FCC CLASS II PERMISSIVE CHANGE REQUEST LETTER

RE: FCC Permissive II Change Request for Company: LG Electronics USA FCC ID: BEJD179NAA

We are submitting an application for a class II permissive change to the FCC approval of the Company name: LG Electronics USA, product description: household electric oven (FCC: **BEJD179NAA**, Original Grant Date: June 14, 2018). The transmitter module itself has not changed. Here are the changes: Changed main PCB

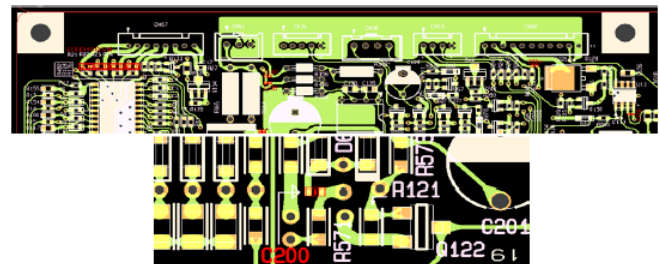
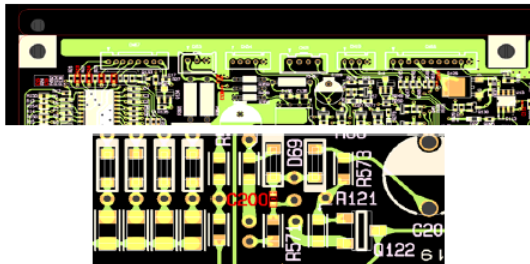
1. MLCC direction : vertical -> horizontal (C137,C138,C13,C14,C15,C16,C224,C112,C104,C200)

2. Connect PCB gnd pattern to earth gnd

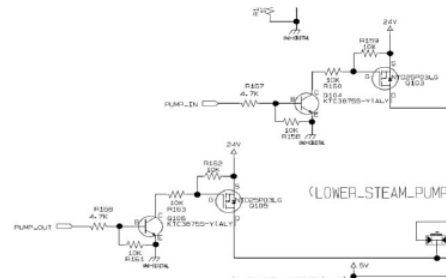
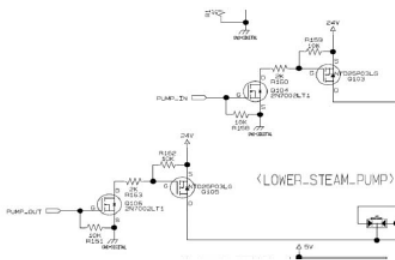
3. Q104, Q106 : 2N7002(FET) -> KTC3875S(TR)

Add R167, R168 : 4.7Kohm

4. R160, R163 : 2Kohm -> 10Kohm
